STAFF REPORT

Subject: Backholm Land Capability Challenge  
81 Observation Drive, Placer County, California  
APN: 093-120-010, TRPA File No.: LCAP2023-0197

Proposed Action:

Attachment A  
Vicinity Map and TRPA Land Capability Map

Attachment B  
Site Photographs (Sept. 07, 2023)

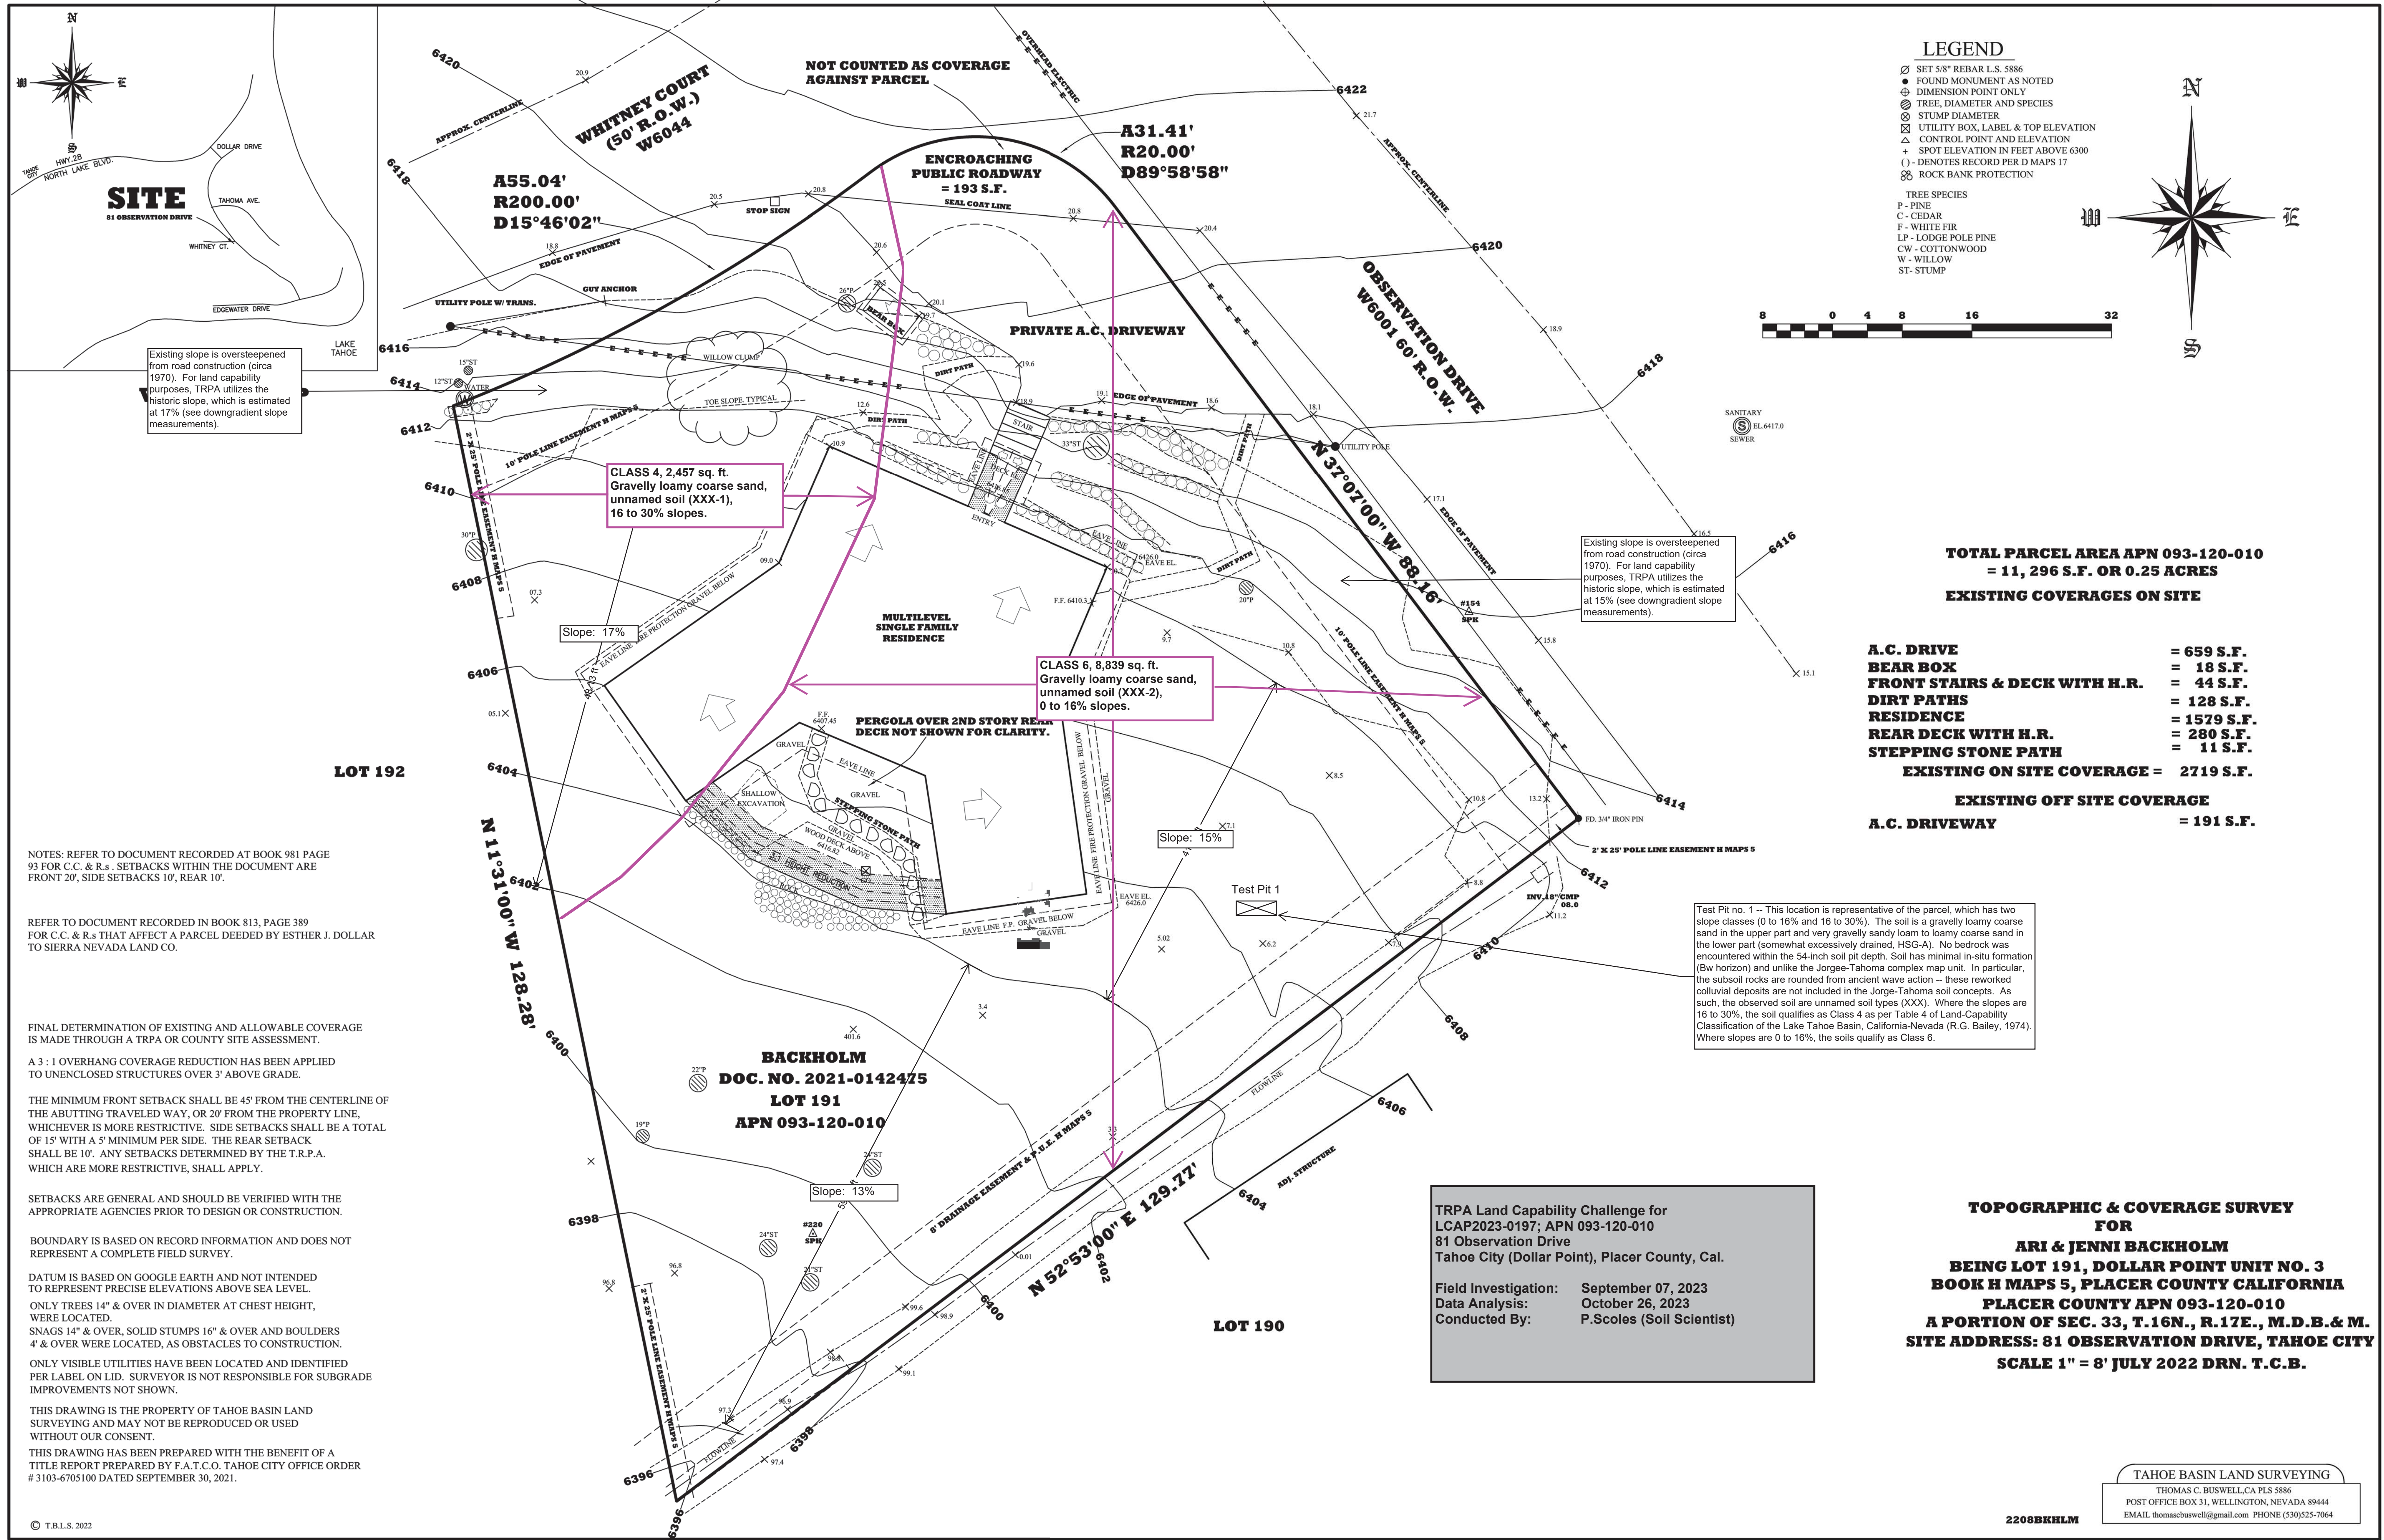
Photo 1 – View southwest at driveway and residence entrance (behind red car). The land surface drops off abruptly (foreground), because it was over-steepened from street construction (circa 1970s). Vegetation consists of Jeffrey pine, incense cedar, ornamental trees, greenleaf manzanita, huckleberry oak, bitterbrush, sagebrush, prostrate ceanothus & creeping snowberry.

Photo 2 – View west at east portion of property (abuts Observation Drive). Natural slopes in this vicinity are roughly 15% (southwest aspect). Visible boulders were placed when road and/or residence constructed (not exposed bedrock).

Photo 3 – View to north at residence located in north-center of parcel. The backyard is partially landscaped near the residence, but mostly native greenleaf manzanita, bitterbrush and grasses in the southern part (foreground). The backyard generally has 13% slopes, so the deep soils qualify this area (and majority of parcel) as Class 6.

Photo 4 – View to southeast edge of parcel where Test Pit no. 1 was excavated by backhoe. The pit was located about 35 feet west of Observation Drive and 15 feet north of the south property line. Slopes are 15% in this vicinity. The test pit showed the property has deep soils that become increasingly more gravelly with depth (no root restriction nor evidence of seasonal water table).

Photo 5 – Close-up view of Test Pit no. 1 showing gravelly-sandy surface layer with many fine and medium roots. While subsoil layers had increasing gravel content, root penetration was still extensive. Fine and medium size roots were observed at a depth of 54+ inches. The underlying substratum (at 39 inches) has rounded pebbles, gravels and cobbles which attained their smooth condition when ancient lake levels occurred at this elevation. This soil is unlike the mapped Umpa series, and unlike the Jorge-Tahoma soil types due to the wave-influenced substratum. This is an unnamed inclusion (XXX). For slopes 16 to 30%, this soil rates as Class 4 and Class 6 for slopes 0 to 6%, as per Table 4 of the land capability system.

Photo 6 – View northwest side of residence (dark building at right), where the natural slope was artificially steeped by road construction (circa 1970s). For land capability purposes, the natural slopes are relied upon. The natural slope remains to the right of the tree and boulders, about 17% in this vicinity. Such slope qualifies this portion of the property as Class 4 for slopes 16 to 30%. The boulders in foreground presumably excavated when residence was constructed.
